ADDENDUM NO. 1

TO: PLANS AND SPECIFICATIONS FOR STATE OF MISSOURI

**Sewer and Water Line Improvements
Weston Bend State Park
Weston, Missouri
Project No. X2322-03**

Bid Opening Date: 1:30 PM, Tuesday, October 15, 2024 (Not Changed)

MICROFAST 9.0 TANK DETAIL
No Scale

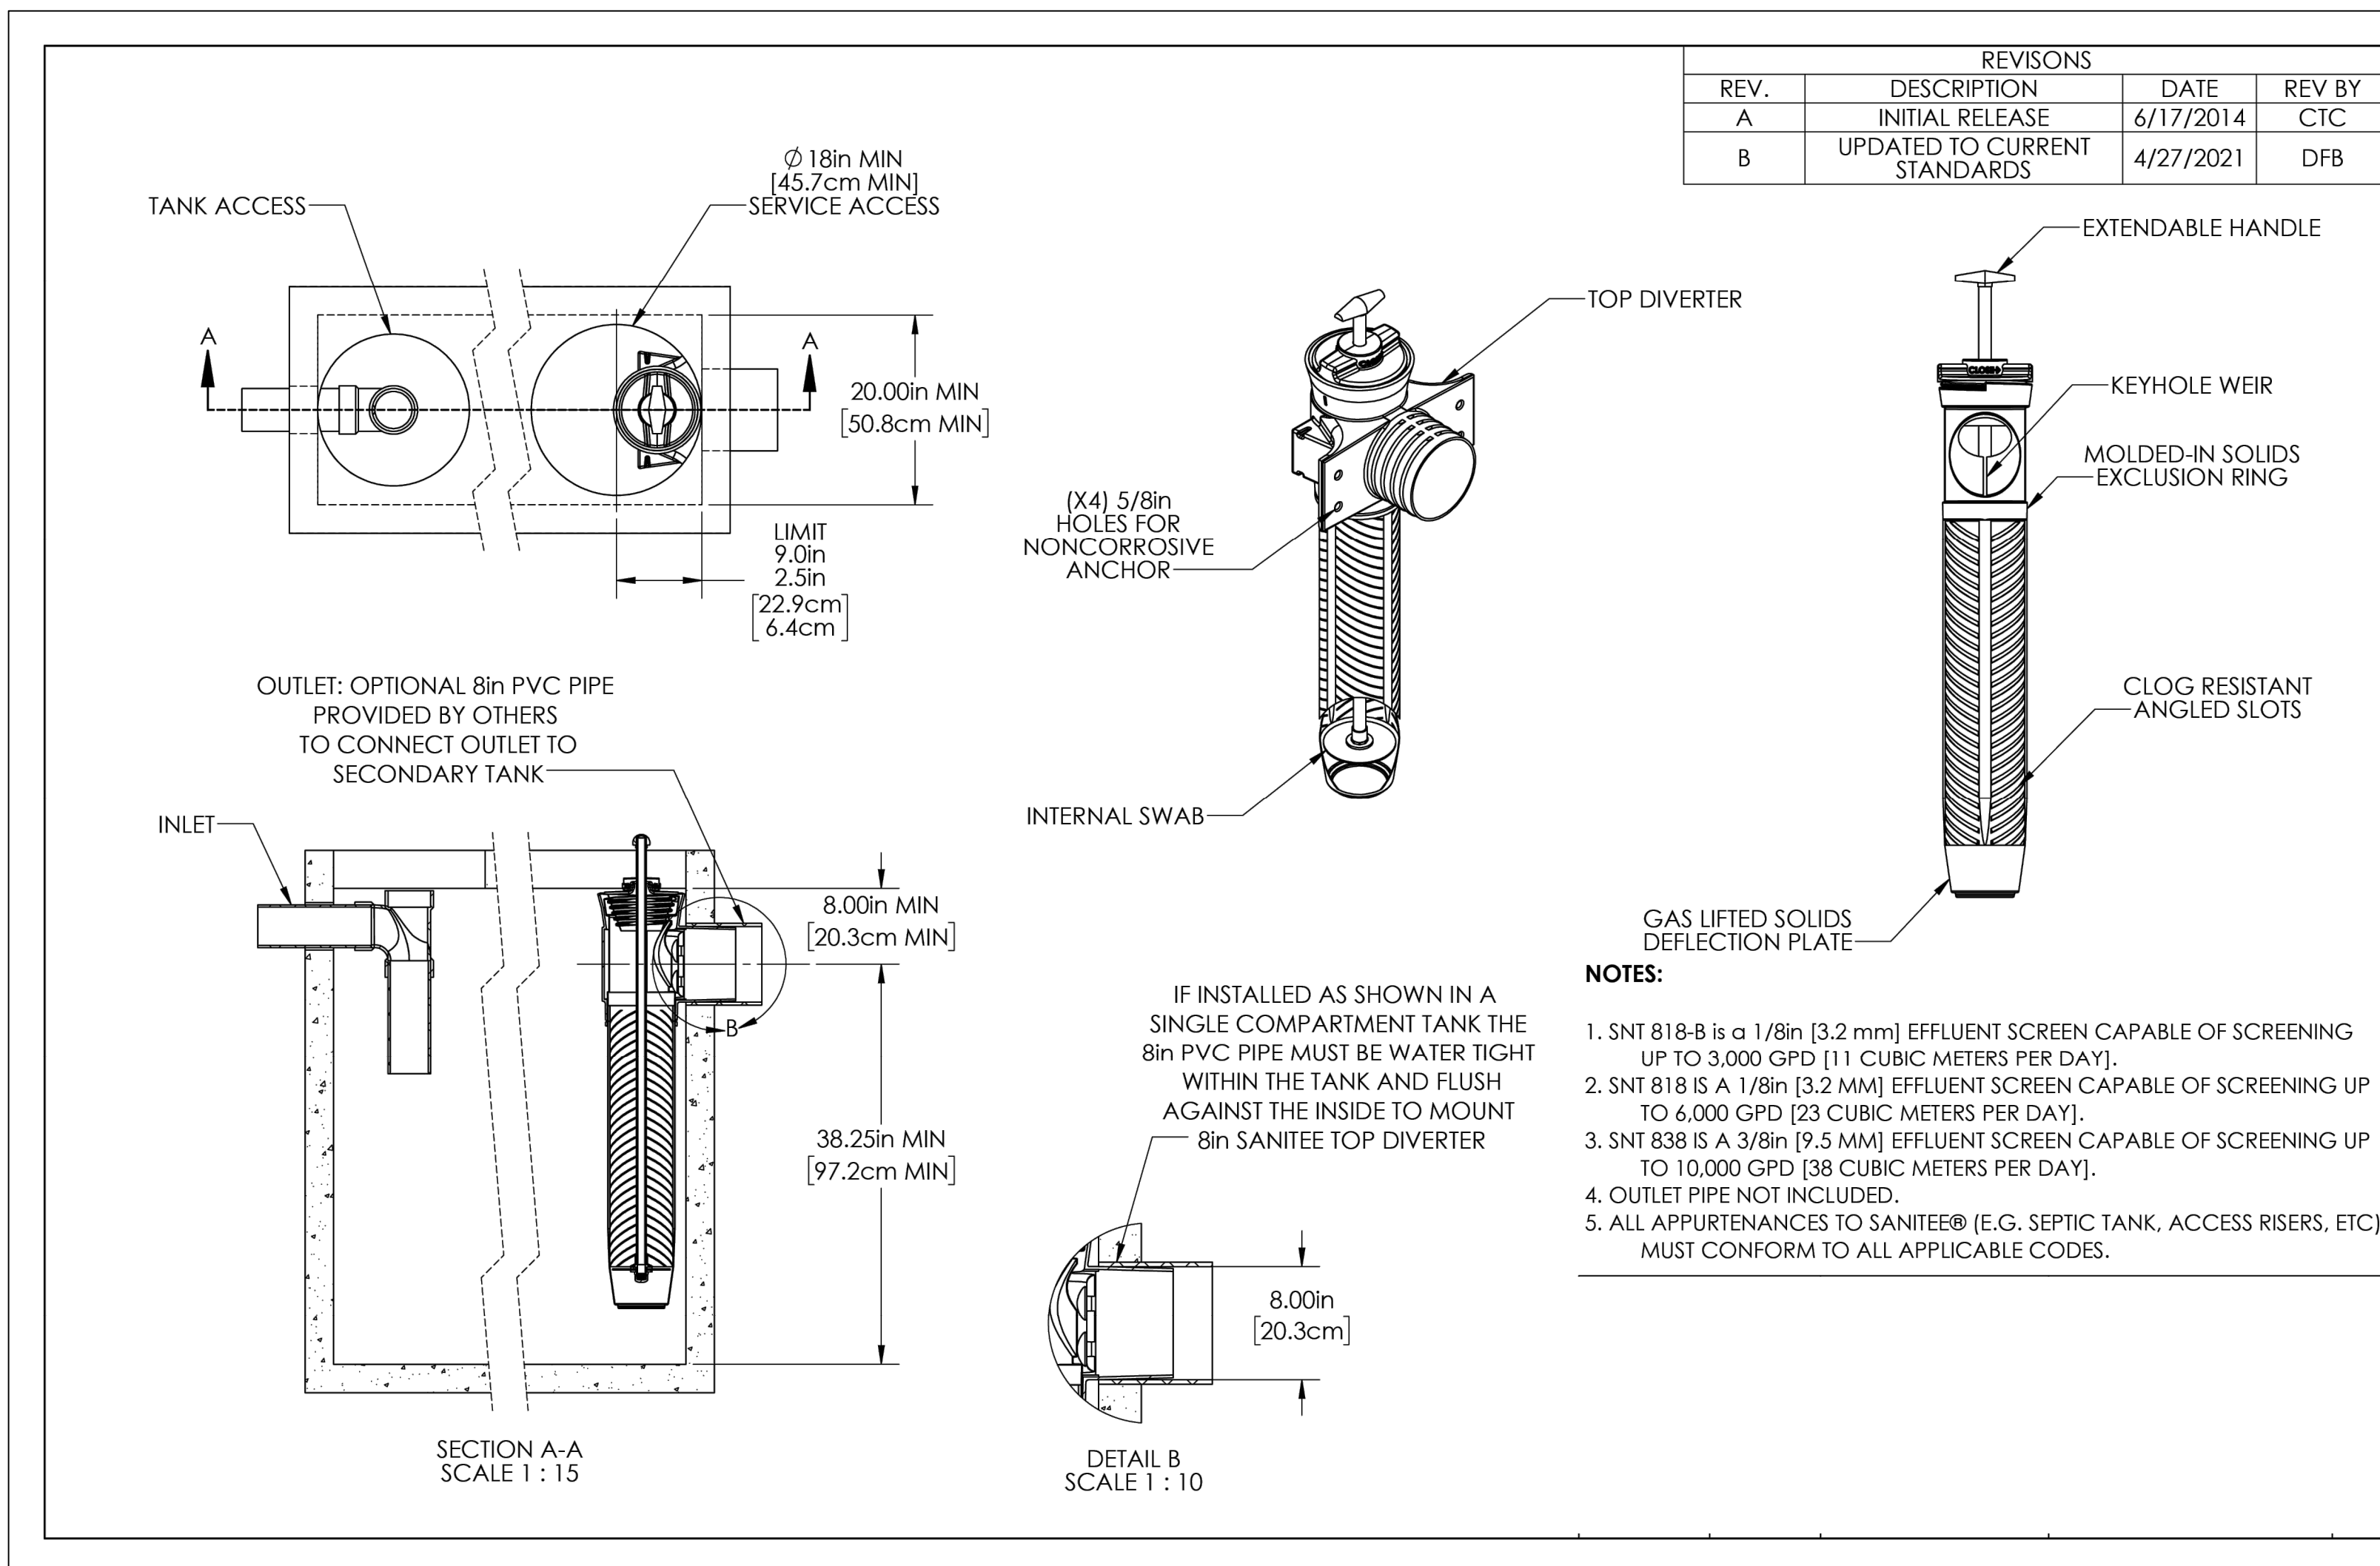
3. Sheet C-106
 - a. Add Air Release Valve to sheet.
 - b. Change EOL to connect into existing 2" line servicing campground at STA. 24+27.72
 - c. See attached revised sheet for revisions.
4. Sheet C-107
 - a. Remove manhole and air release valve details.
 - b. Add Grinder Pump detail.
 - c. Add SaniTEE detail.
 - d. Add MicroFAST 9.0 detail.
 - e. Add 4,000 gal Septic Tank detail.
 - f. See attached revised sheet for revisions.
